# **SUBJECT:** Administrative Approval for Petition No. 2003-13 by First LandMark USA.

Rezoning Technical Data

Coventry Court Townhomes First LandMark, USA / Llewellyn Development, L

Schematic Site Plan

Sheet No: RZ-2

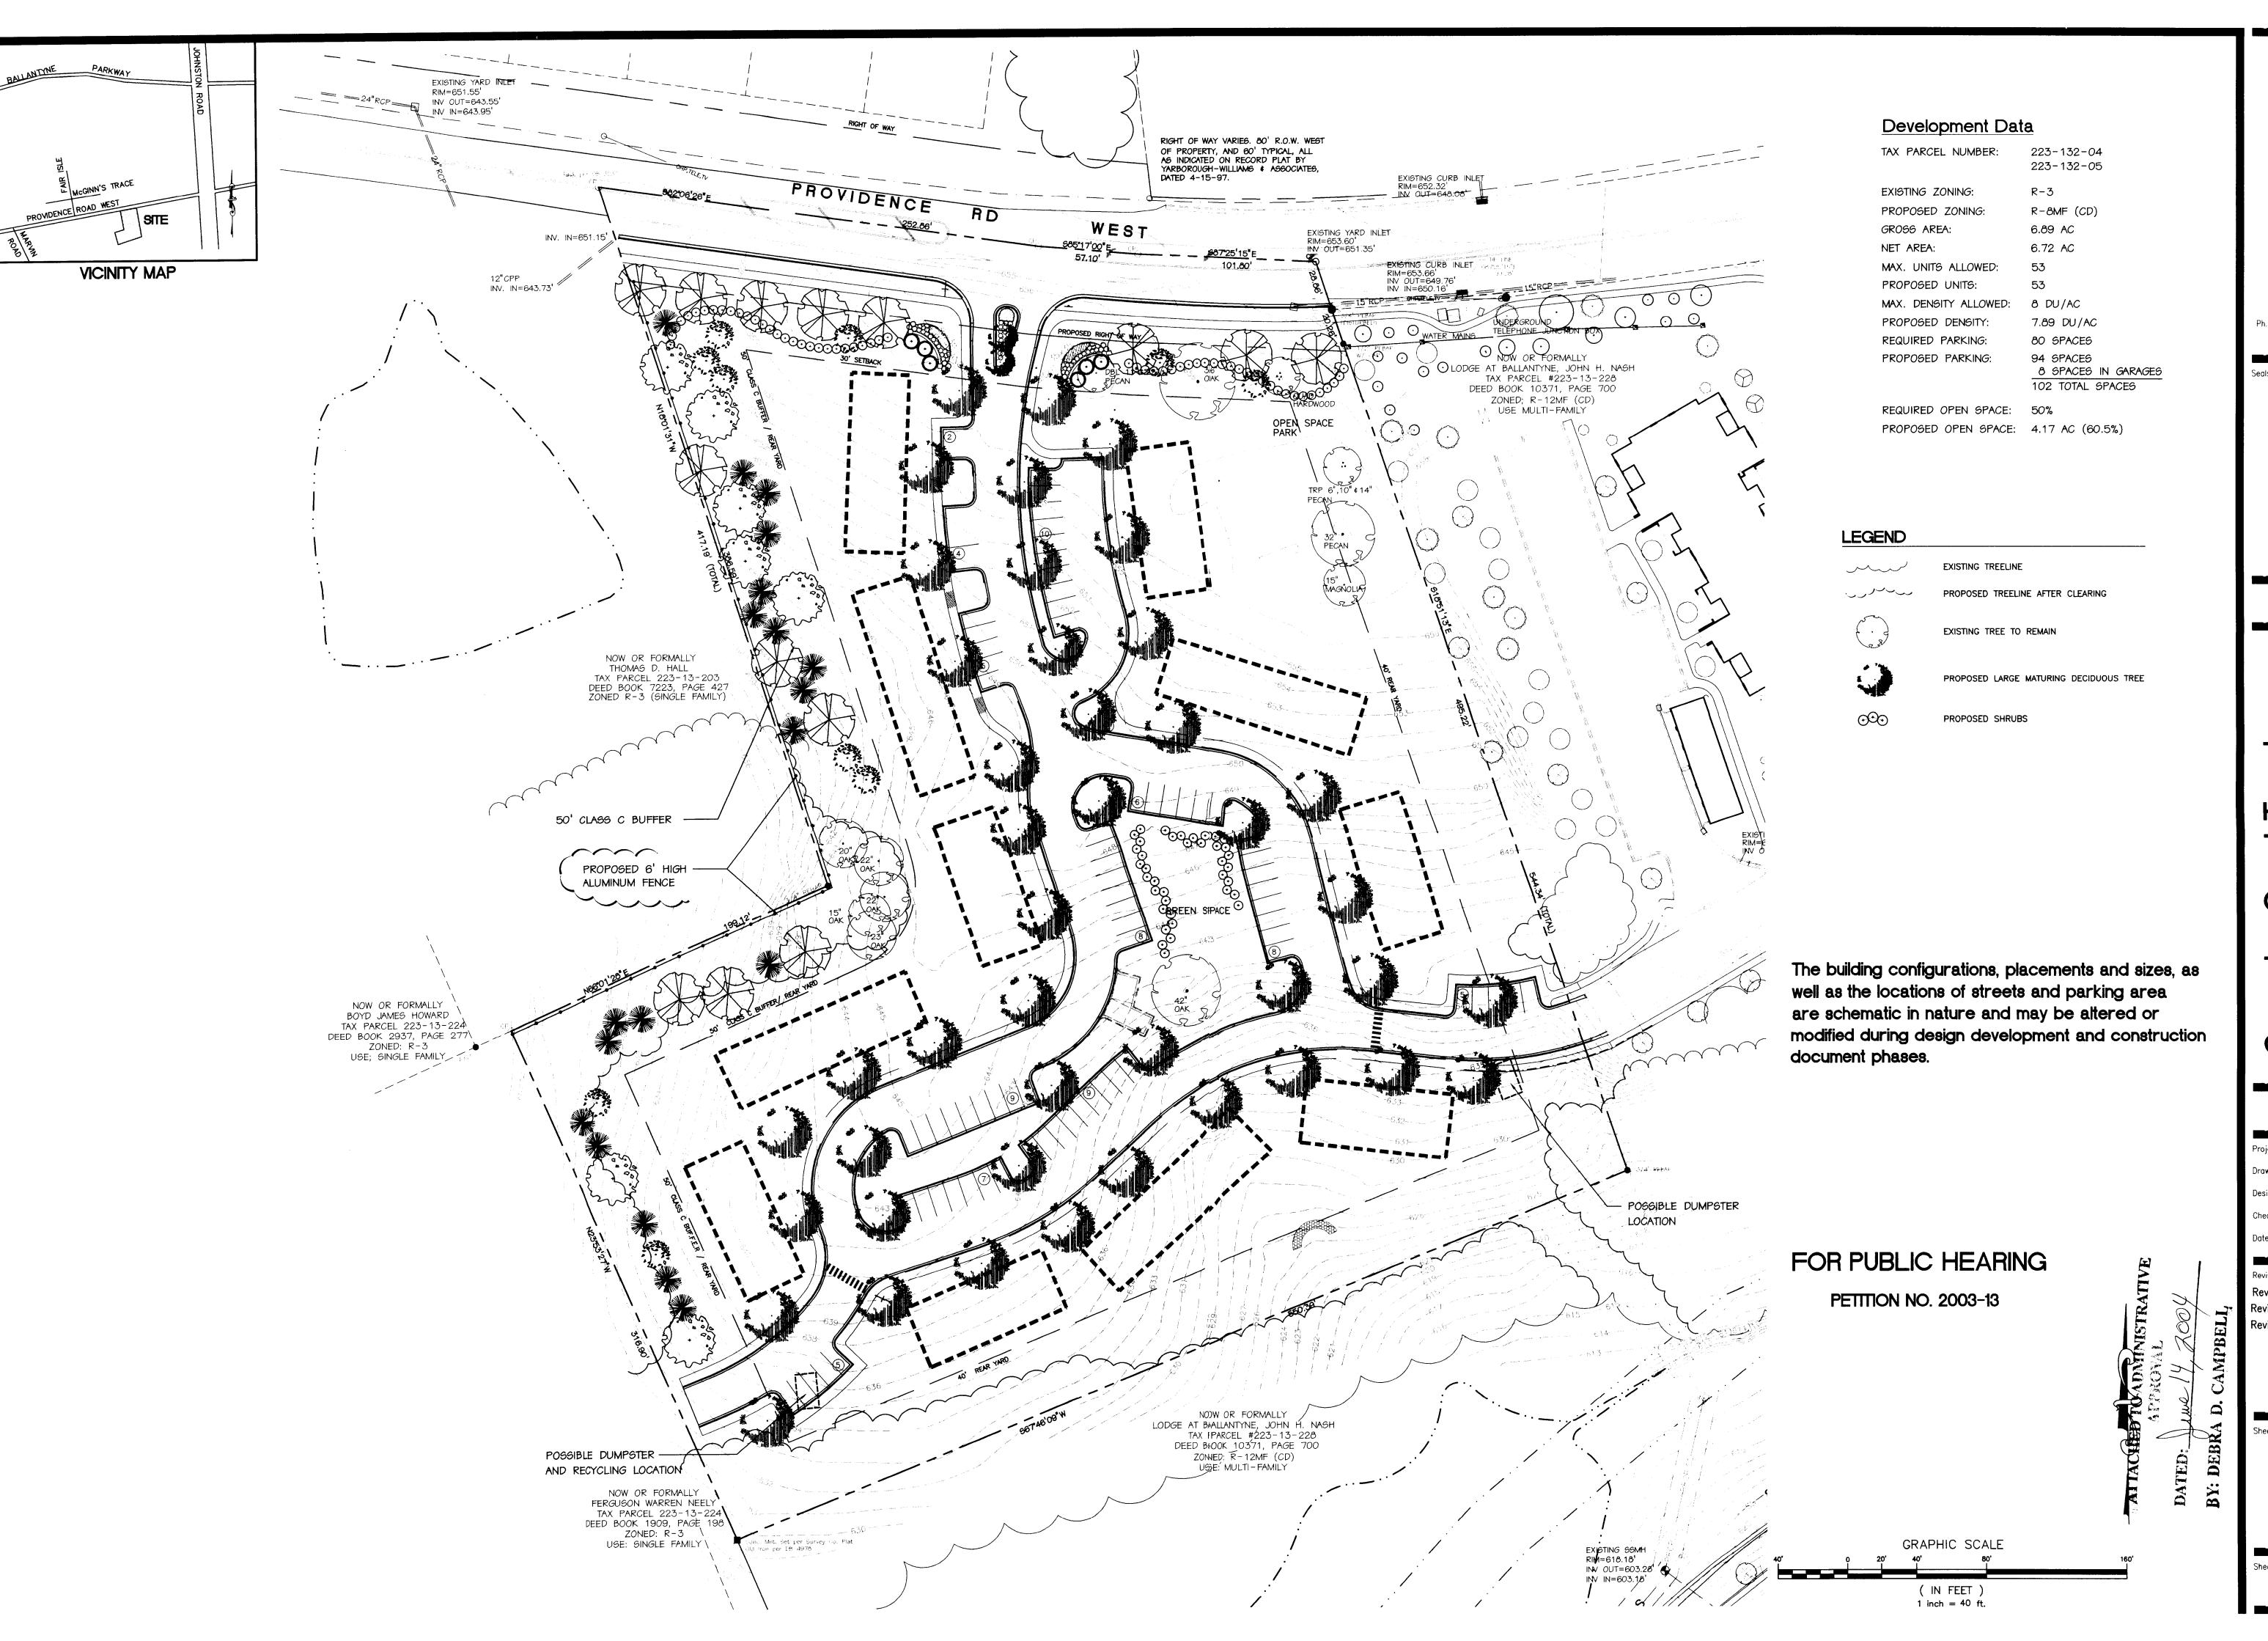
Attached are revised plans for the above petition. The plan has been revised to allow a 6-foot high aluminum fence along the western property line instead of a 6-foot high wooden fence. Since this change is minor, I am administratively approving these revised plans. Please use these plans when evaluating requests for building permits and certificates of occupancy. Note that all other conditional notes and ordinance requirements still apply.
